CROSSROADS LOGISTICS CENTER

**8400 E PARMER LANE
SP-2021-0015D**

VARIANCE REQUEST

PROPOSED SITE PLAN & GRADING

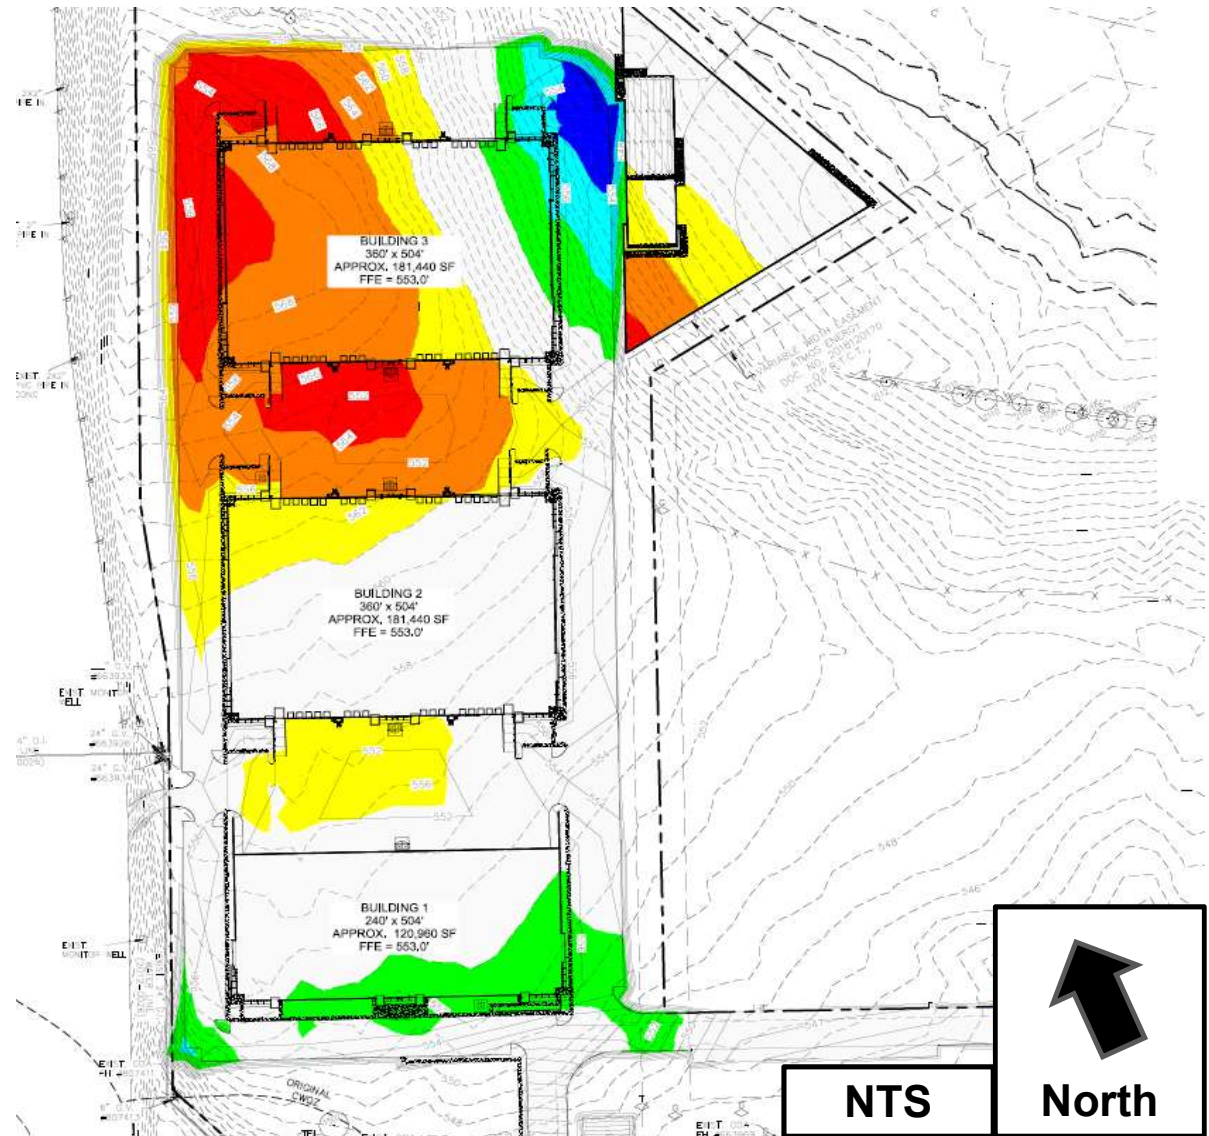
- **To allow cut in excess of four feet and up to 14.3 feet within the Desired Development Zone. (LDC 25-8-341)**
- **To allow fill in excess of four feet and up to 16.5 feet within the Desired Development Zone. (LDC 25-8-342)**

MAXIMUM CUT = 14.3 FEET
MAXIMUM FILL = 16.5 FEET

SITE PLAN ENLARGEMENT

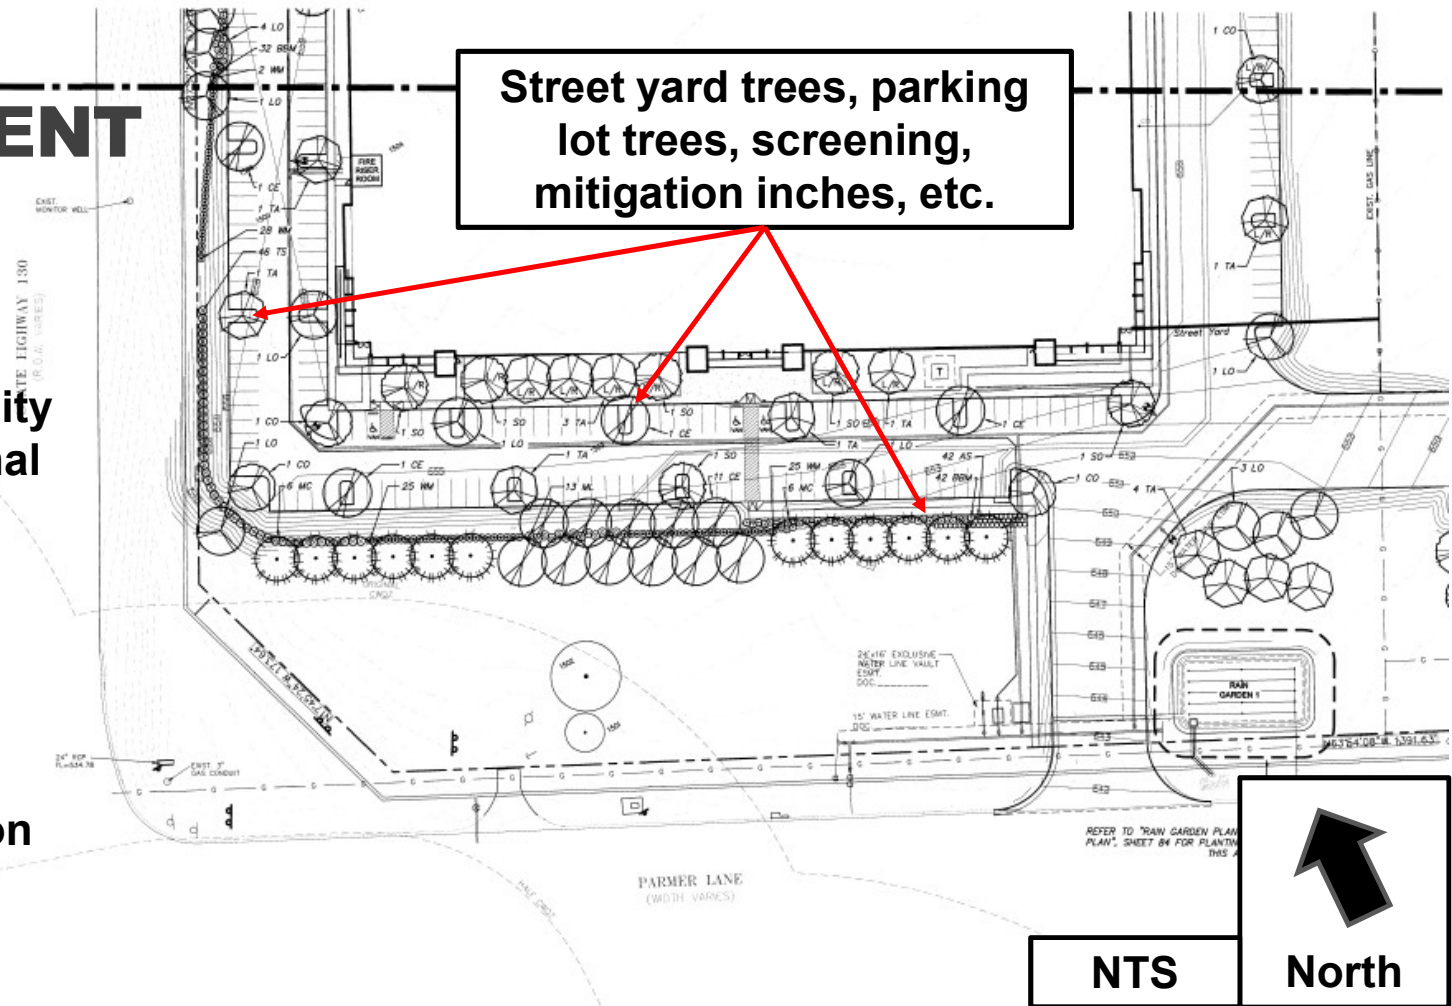
- Wetland CEF setback expanded from 150 feet to 200 feet
- Retaining walls to structurally contain cut and fill and minimize the amount of grading

- Landscaping and tree replacement / mitigation in accordance with City zoning jurisdictional requirements
- Total mitigation inches planted on site is a 194
- Total non-mitigation inches planted on site is 602.5

- Provide a landscape plan in accordance with City zoning jurisdictional requirements.
- Provide tree replacement & mitigation plan in accordance with City zoning jurisdictional requirements.
- Increase the wetland CEF setback from 150 feet to 200 feet.
- Provide structural containment of the cut with retaining walls.
